SERVICE BULLETIN

N° 139-699

ATA 33 – TAIL ROTOR LIGHTS IMPROVEMENT

This Service Bulletin is issued to provide the necessary instruction to perform the Tail Rotor Lights retromod P/N 3G3340P02011.

Figure 1

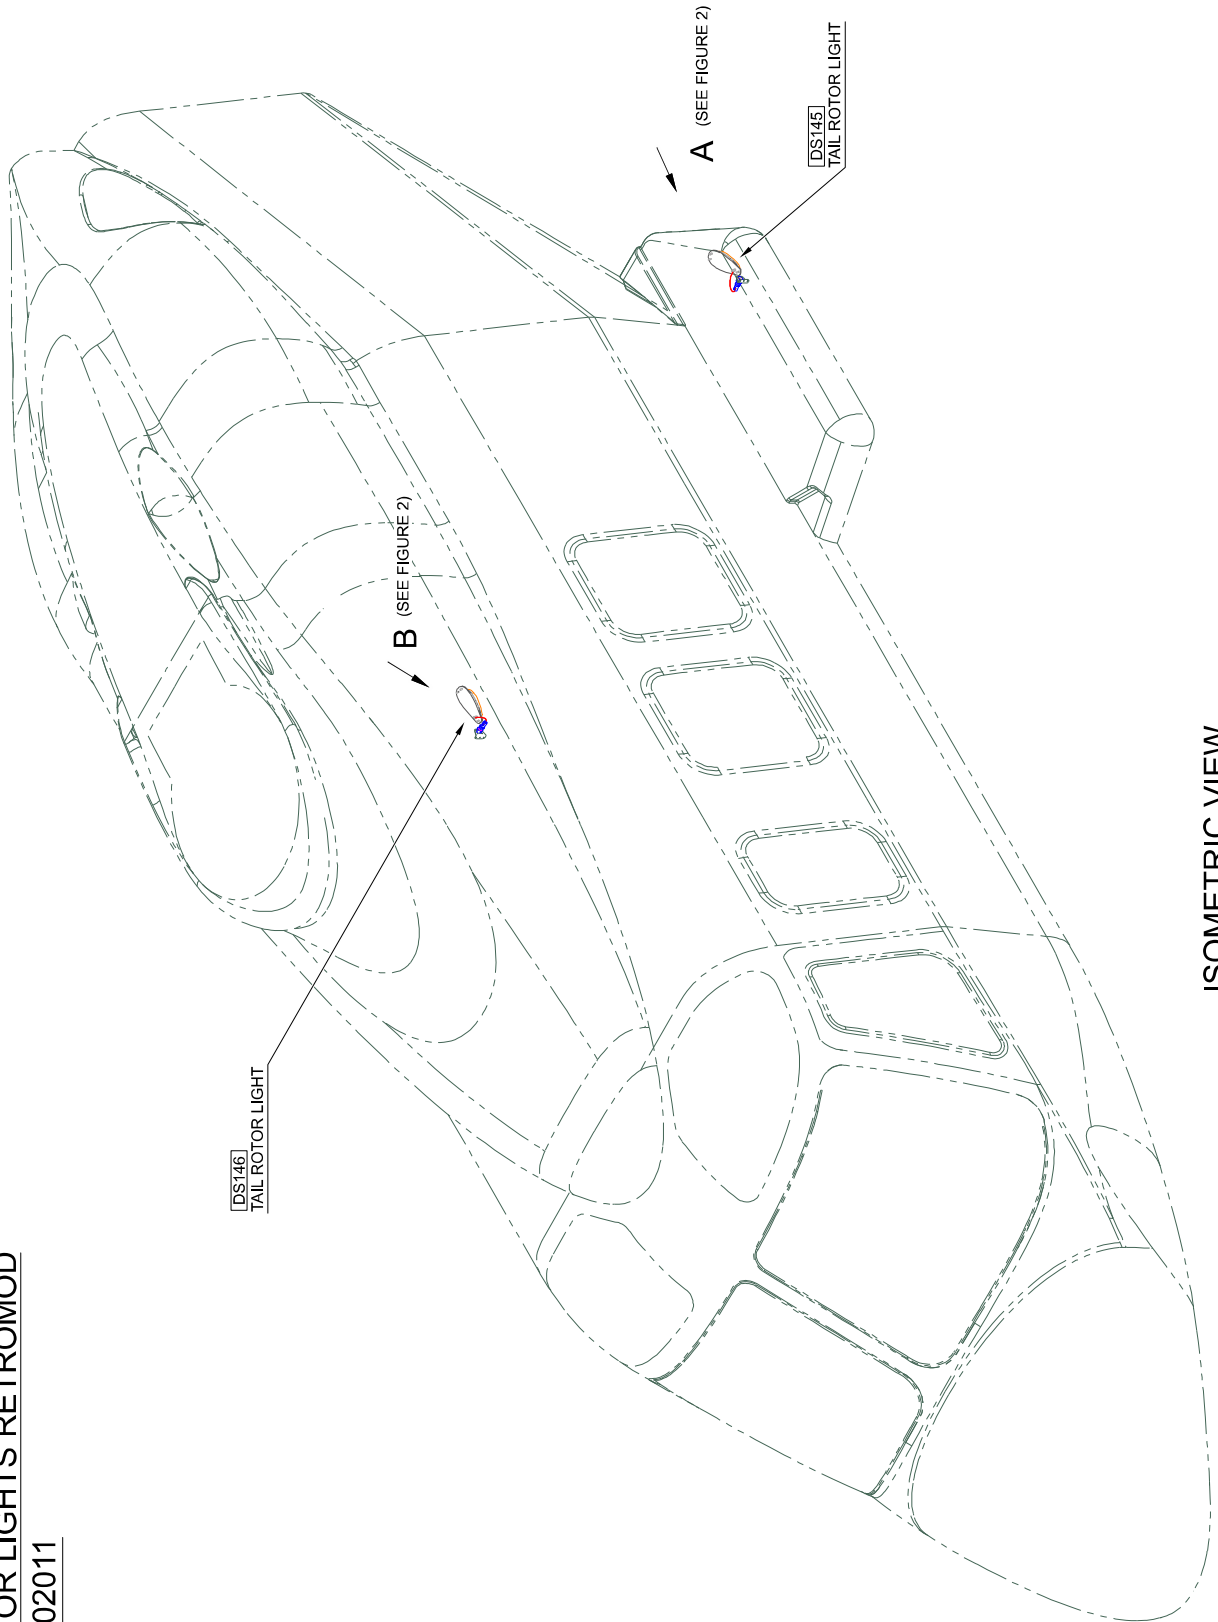
2. In accordance with AMP DM 39-A-06-41-00-00A-010A-A and with reference to Figure 1 thru Figure 4, remove all external panels as required to gain access to the area affected by the installation and perform the tail rotor lights retromod P/N 3G3340P02011 as described in the following procedure:

Figure 2

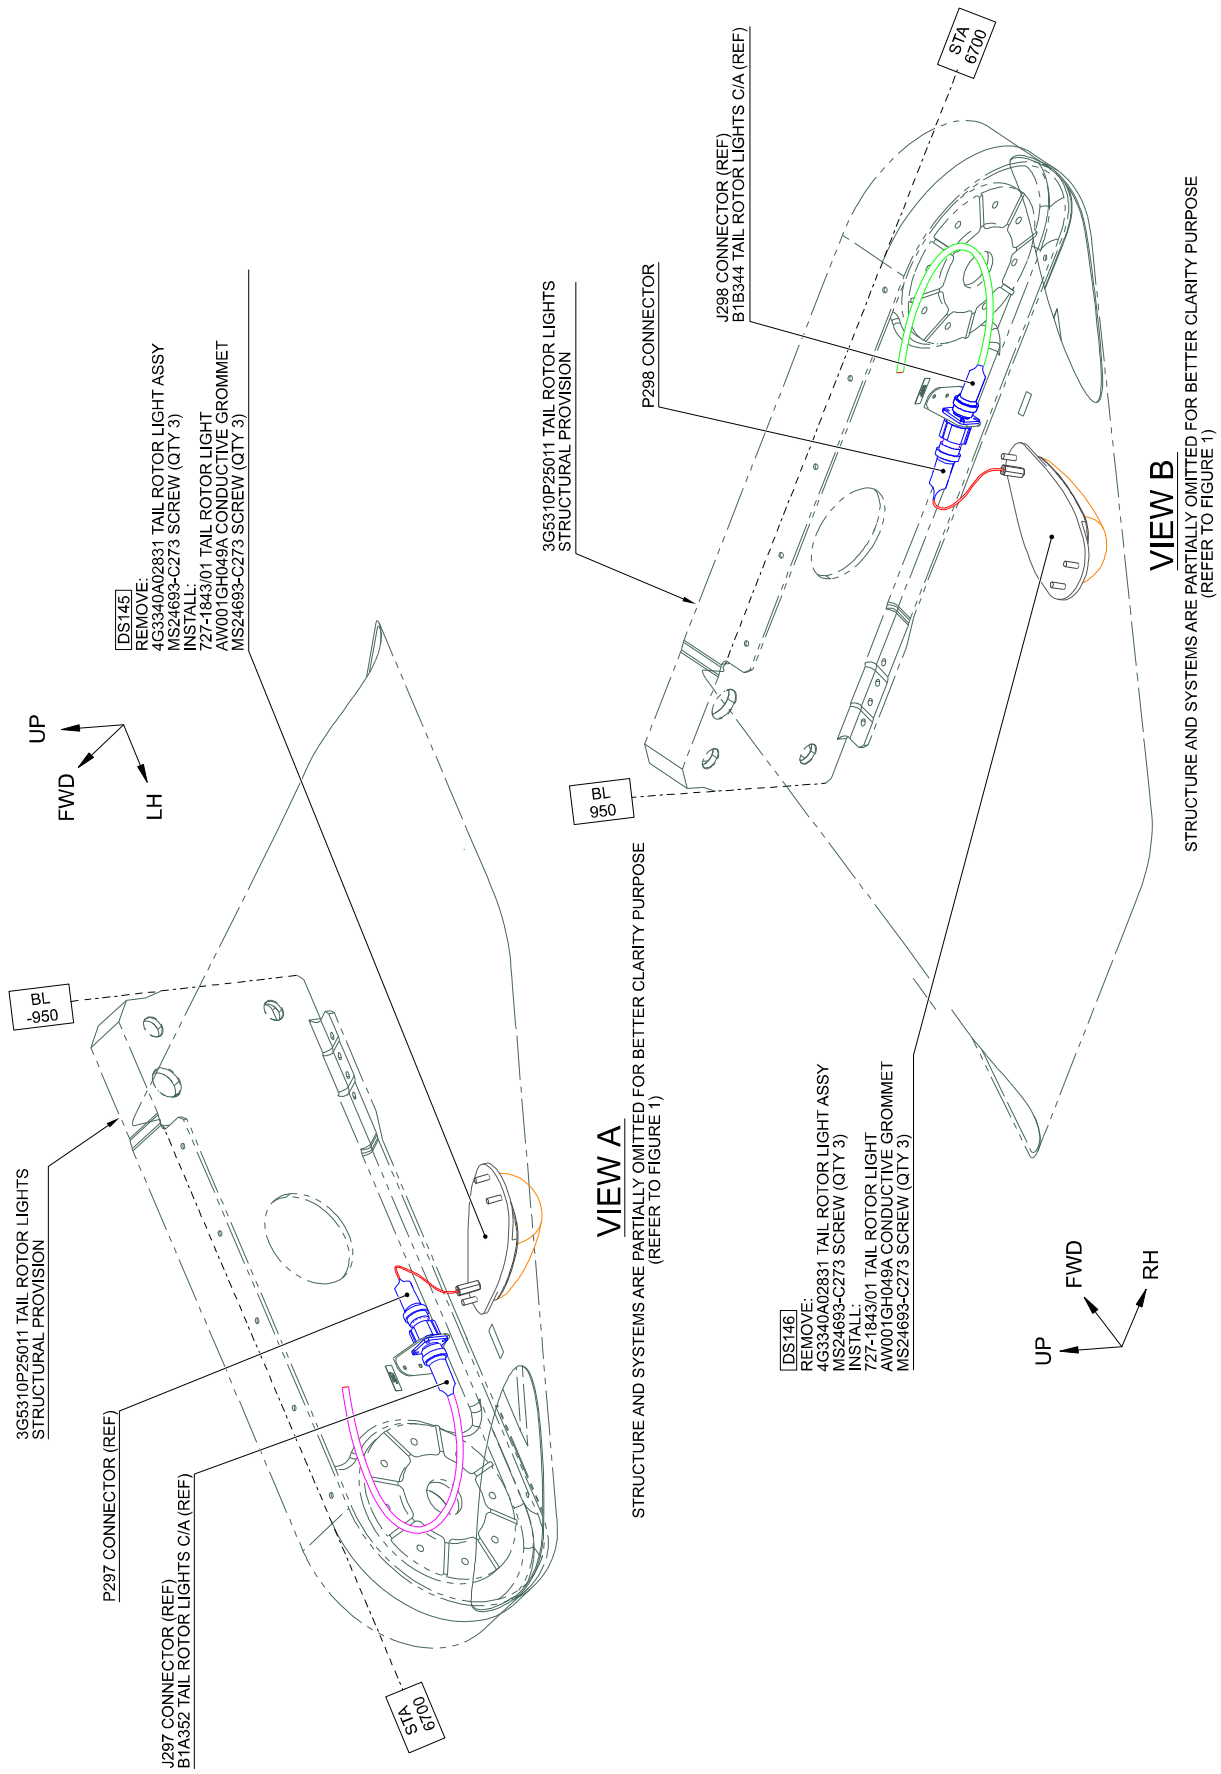
- 2.1 Perform the structural provision P/N 3G5310P25011 as described in the following procedure:
 - 2.1.1 With reference to Figure 2 View A, disconnect the connector J297 from the connector P297 of the LH tail rotor light assy P/N 4G3340A02831 (DS145).

- 2.1.2 With reference to Figure 2 View A, remove the n°3 existing screws P/N MS24693-C273 and the LH tail rotor light assy P/N 4G3340A02831 (DS145) from the LH fairing P/N 3G5339A01932.

- 2.1.9 With reference to Figure 2 View B, disconnect the connector J298 from the connector P298 of the RH tail rotor light assy P/N 4G3340A02831 (DS146).

- 2.1.10 With reference to Figure 2 View B, remove the n°3 existing screws P/N MS24693-C273 and the RH tail rotor light assy P/N 4G3340A02831 (DS146) from the RH fairing P/N 3G5339A01832.

- 2.2 With reference to Figure 2 View A, install the conductive gasket P/N AW001GH049A and the LH T/R light P/N 727-1843/01 (DS145) on the fairing P/N 3G5339A01932 by means of n°3 screws P/N MS24693-C273.
- 2.3 Remove the protective plugs previously installed on the connectors and with reference to Figure 2 View A, connect the connector P297 of the LH T/R light DS145 to the connector J297.

- 2.4 With reference to Figure 2 View B, install the conductive gasket P/N AW001GH049A and the RH T/R light P/N 727-1843/01 (DS146) on the fairing P/N 3G5339A01832 by means of n°3 screws P/N MS24693-C273.

- 2.5 Remove the protective plugs previously installed on the connectors and with reference to Figure 2 View B, connect the connector P298 of the RH T/R light DS146 to the connector J298.

Figure 3

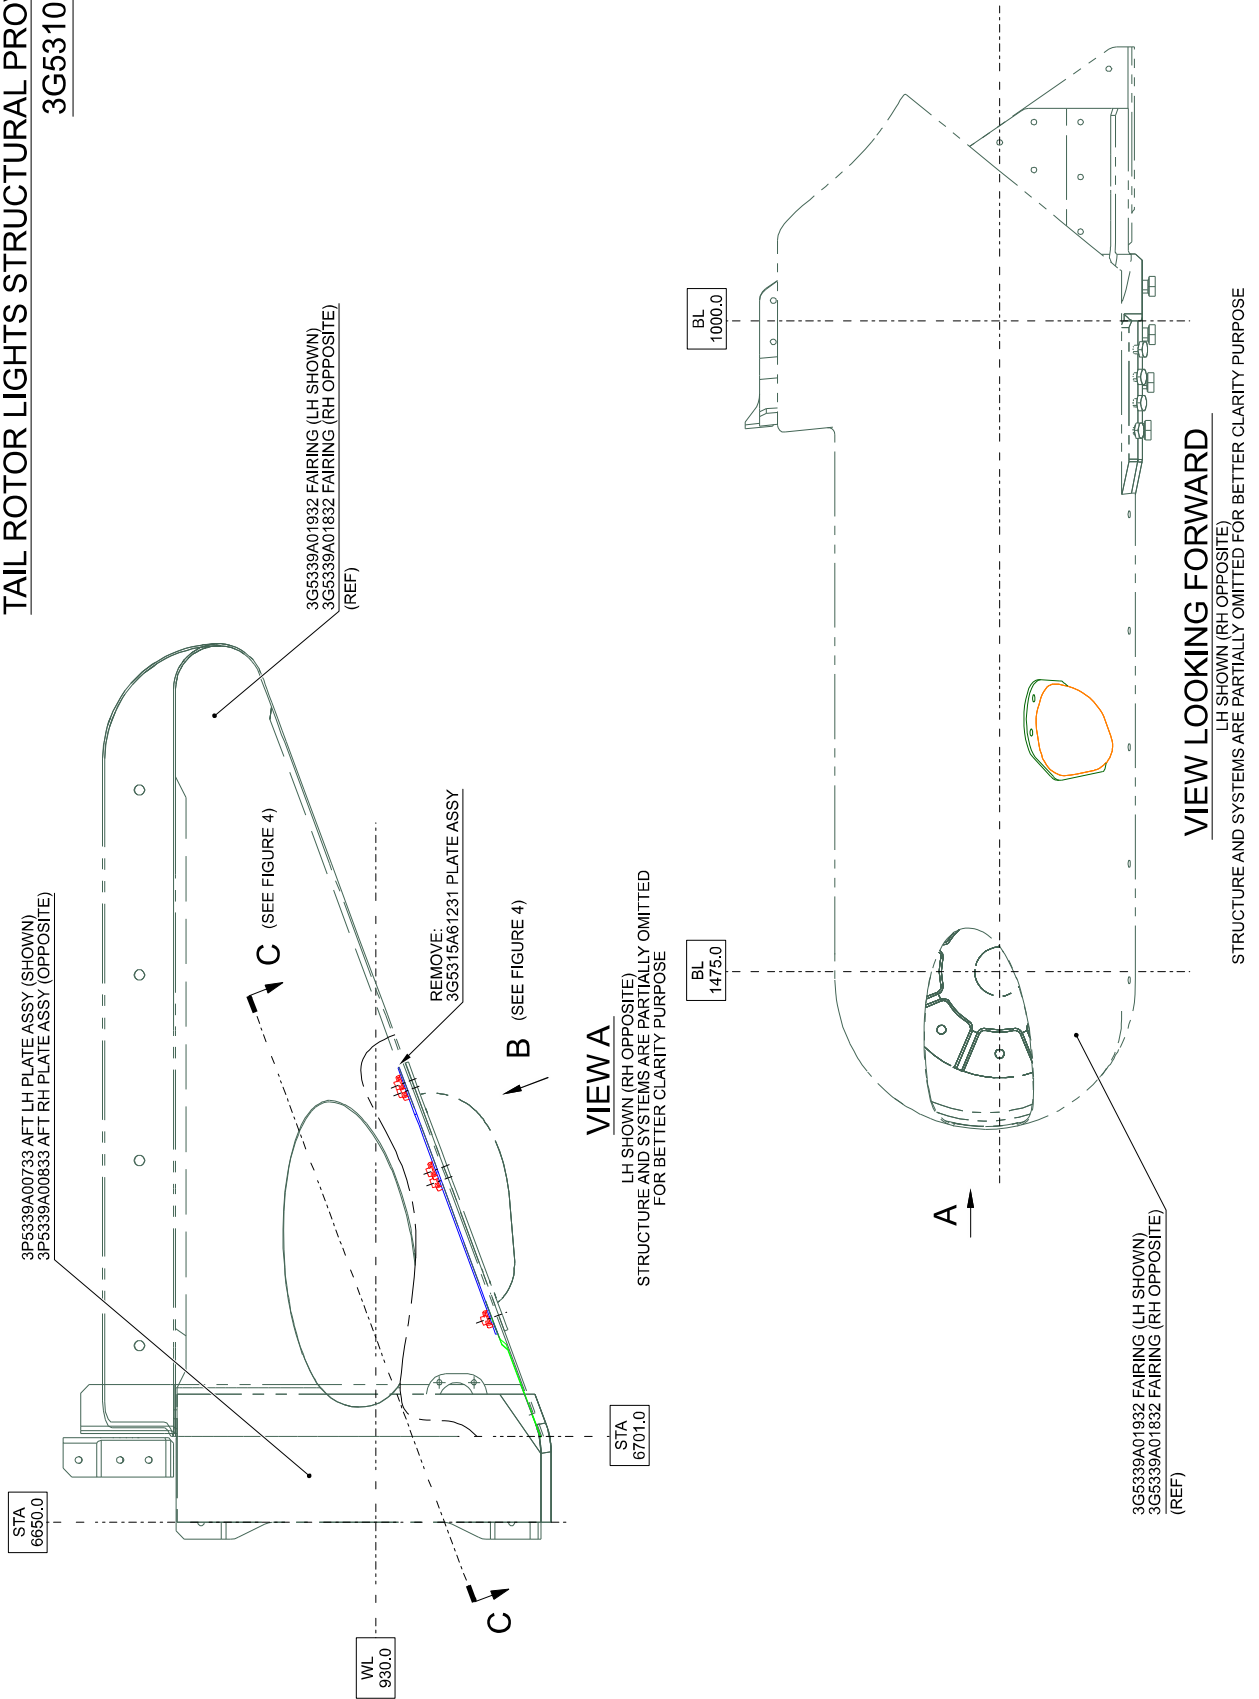
- 2.1.3 With reference to Figure 3 View A, remove the plate assy P/N 3G5315A61231 from the LH fairing P/N 3G5339A01932.
 - 2.1.4 With reference to Figure 4 Section D-D, plug the n°2 existing holes on the LH fairing P/N 3G5339A01932 by means of adhesive EA9309.3NA (C231).

- 2.1.11 With reference to Figure 3 View A, remove the plate assy P/N 3G5315A61231 from the RH fairing P/N 3G5339A01832.
- 2.1.12 With reference to Figure 4 Section D-D, plug the n°2 existing holes on the RH fairing P/N 3G5339A01832 by means of adhesive EA9309.3NA (C231).

Figure 4

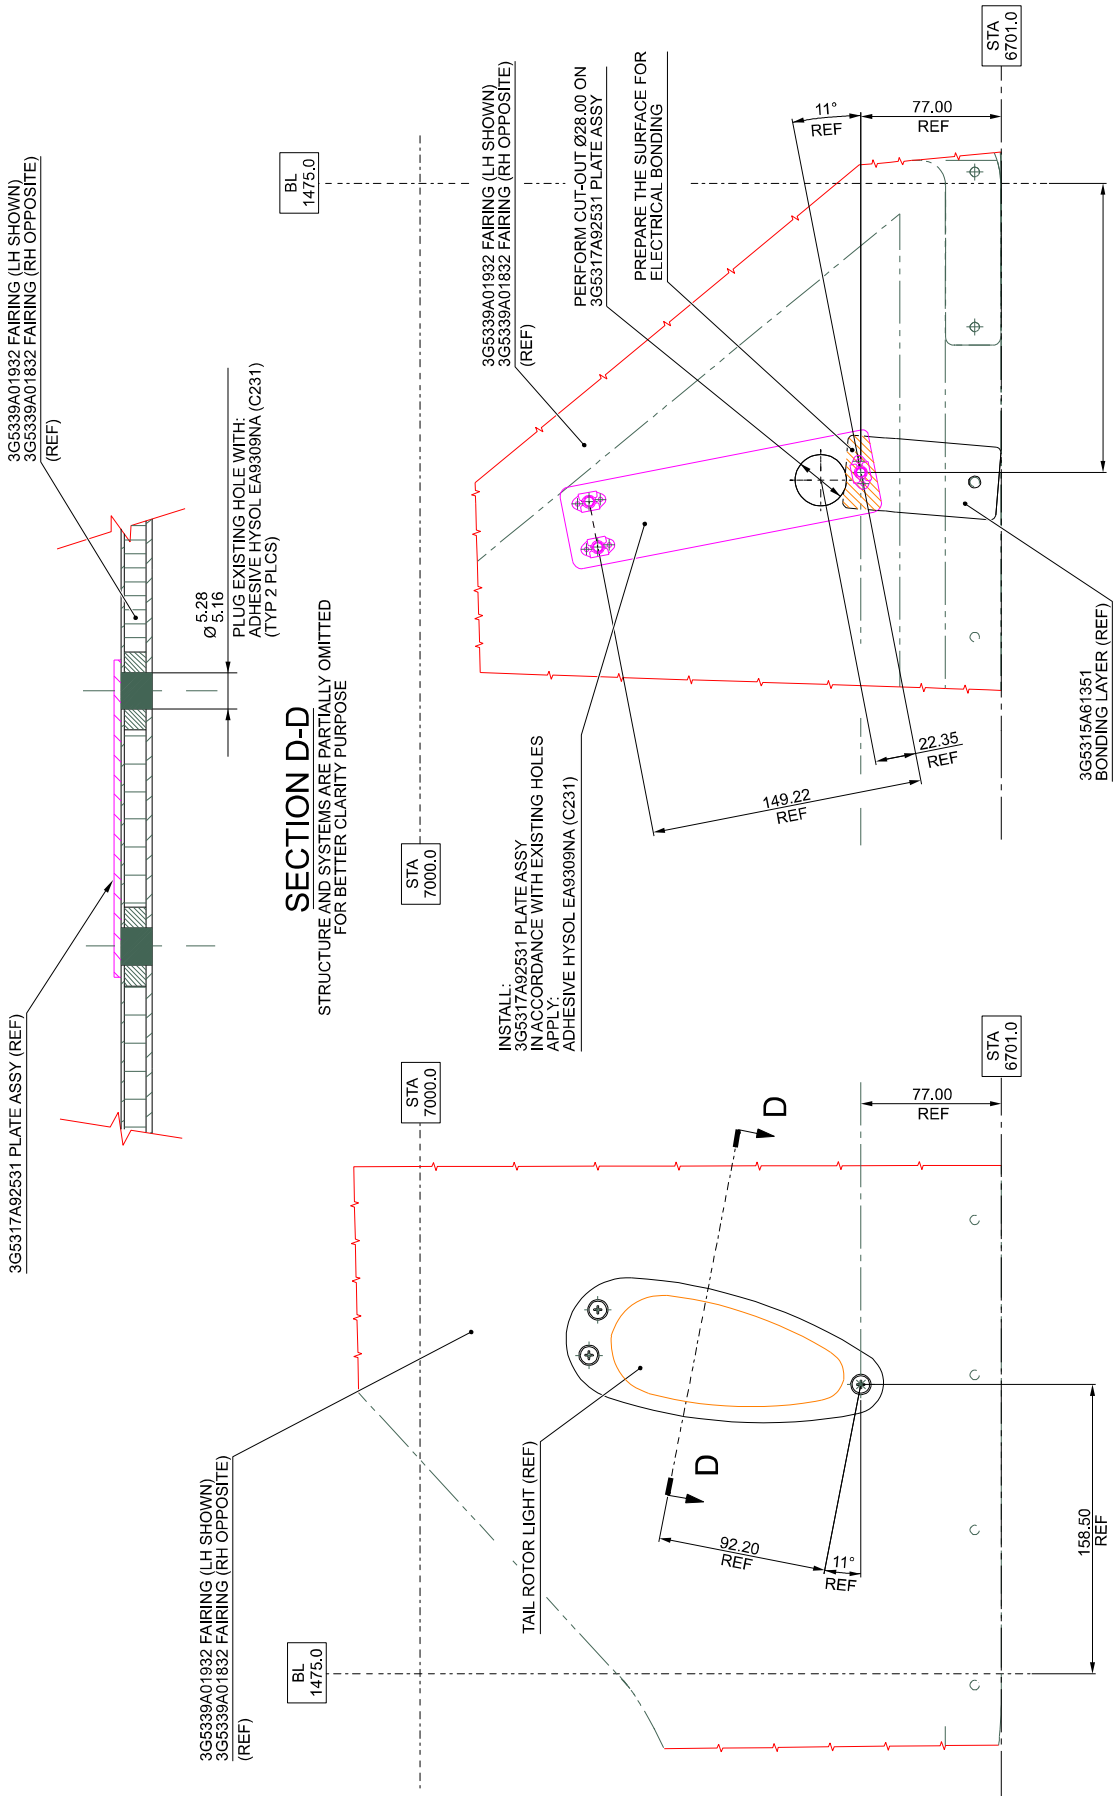
- 2.1.6 With reference to Figure 4 Section C-C, perform the cut-out \varnothing 28.00 on the LH plate assy P/N 3G5317A92531 in accordance with the dimensions shown.

- 2.1.7 With reference to Figure 4 Section C-C, prepare for electrical bonding the mating surfaces of the LH plate assy P/N 3G5317A92531 and the bonding layer P/N 3G5315A61351.

- 2.1.8 With reference to Figure 4 Section C-C, install the plate assy P/N 3G5317A92531 on the LH fairing P/N 3G5339A01932 by means of adhesive EA9309.3NA (C231) in accordance with the dimensions shown.

- 2.1.13 With reference to Figure 4 Section C-C, perform the cut-out Ø 28.00 on the RH plate assy P/N 3G5317A92531 in accordance with the dimensions shown.

- 2.1.14 With reference to Figure 4 Section C-C, prepare for electrical bonding the mating surfaces of the RH plate assy P/N 3G5317A92531 and the bonding layer P/N 3G5315A61351.

- 2.1.15 With reference to Figure 4 Section C-C, install the plate assy P/N 3G5317A92531 on the RH fairing P/N 3G5339A01832 by means of adhesive EA9309.3NA (C231) in accordance with the dimensions shown.
